ECE/TRANS/WP.29/2009/67
9 April 2009

Proposal for Supplement 1 to the 01 series of amendments to Regulation No. 55
(Mechanical couplings)

Submitted by the Working Party on Brakes and Running Gear */

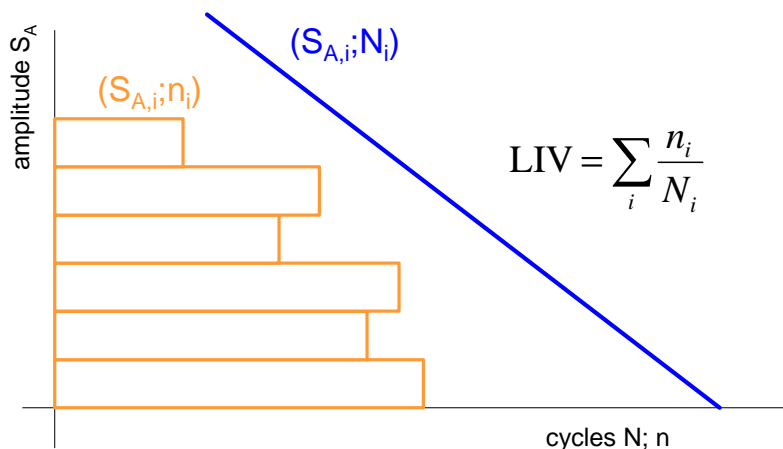
Add new paragraphs 3.10. to 3.10.4., to read:

"3.10. Alternative endurance test for coupling balls and towing brackets with a D-value ≤ 14 kN.

Alternatively to the test procedure described in paragraph 3.1., coupling balls and towing brackets with a D-value ≤ 14 kN can be tested under the following conditions.

3.10.1. Introduction

The endurance test described below consists of a multi-axial test with 3 load directions, with simultaneously introduced forces, defined maximum amplitudes and fatigue equivalences (load intensity values, according to the definition given below).
